METROPOLITAN AREA PLANNING
COMMISSION

Re: S/D 83-31 - Final plat of Phillips Riverside Addition

Preliminary plat
SUBDIVISION REPORT

Re: S/D 83-31 - Preliminary plat of Phillips Riverside
Addition

The enclosed "marked" copy of the final plat is for your information and files.

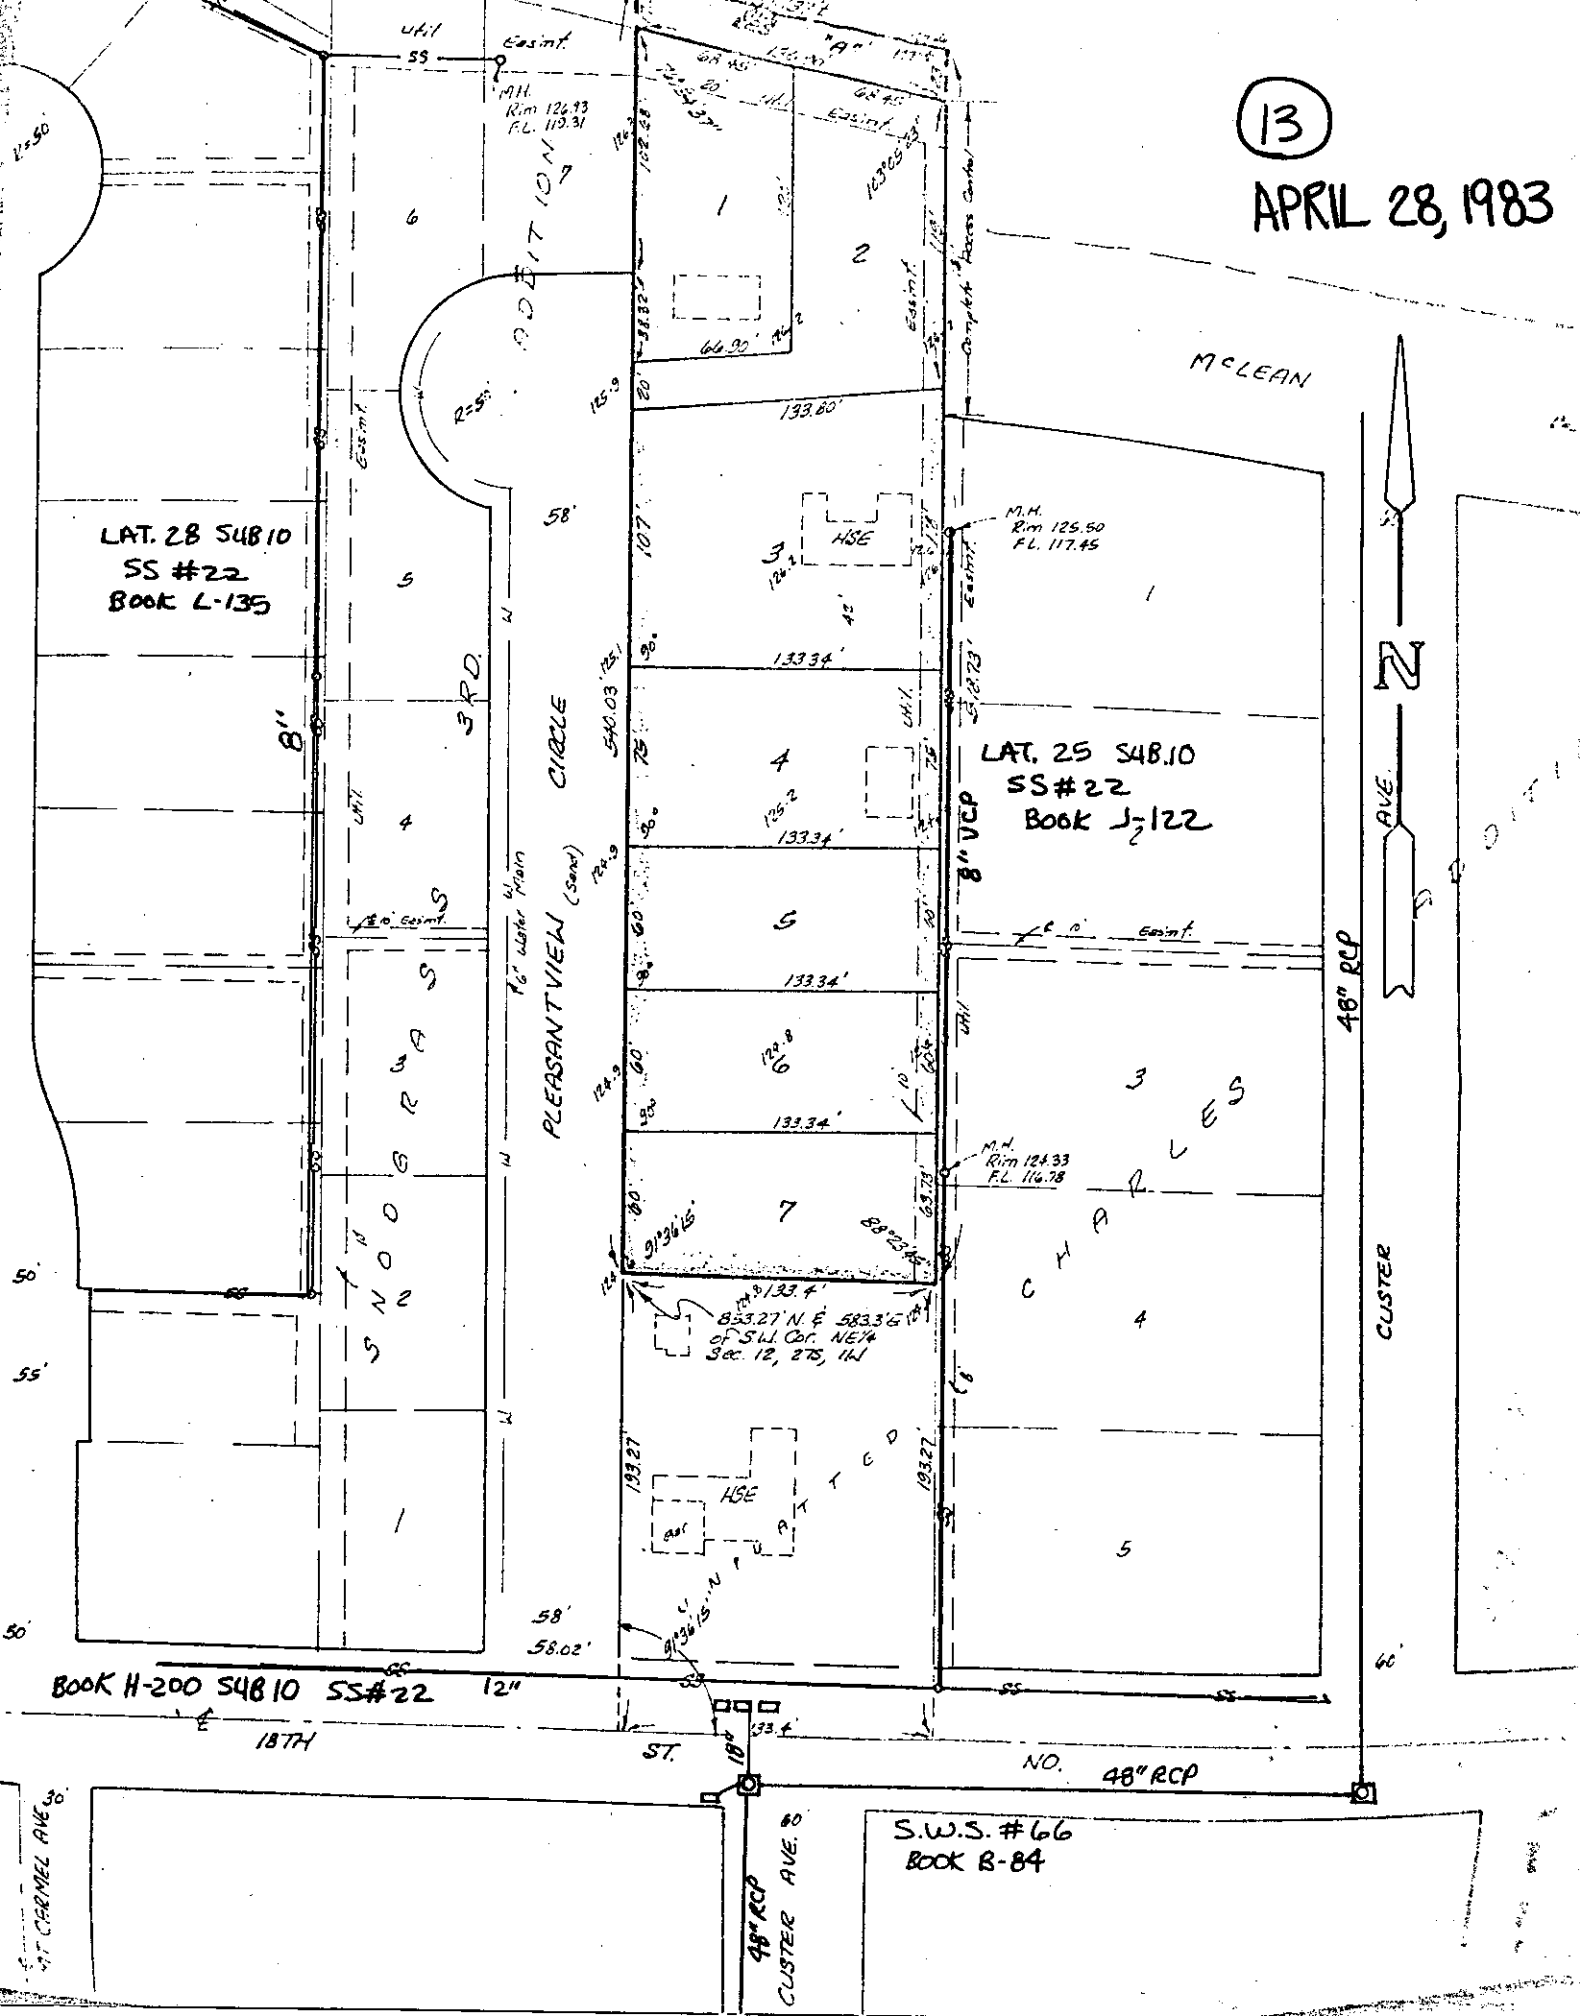
- A. The applicant shall guarantee the extension of sanitary sewer to serve those lots not already served.
- B. City Engineering has advised that sanitary sewers in this area are shallow.

- D. Since Pleasantview Circle was platted with 58 feet of right-of-way, the applicant shall submit a covenant to be recorded with the plat which provides that there will be four off-street parking spaces per dwelling unit.

- E. The applicant is hereby advised that if the existing structure on Lot 1 is to remain, it cannot be expanded within the 25-foot setback from Pleasantview Circle that is required by the "AA" zoning district.

- F. Closure computations shall be submitted with the final plat tracing.
- G. Recording of the plat within 30 days after approval by the Board of City Commissioners.
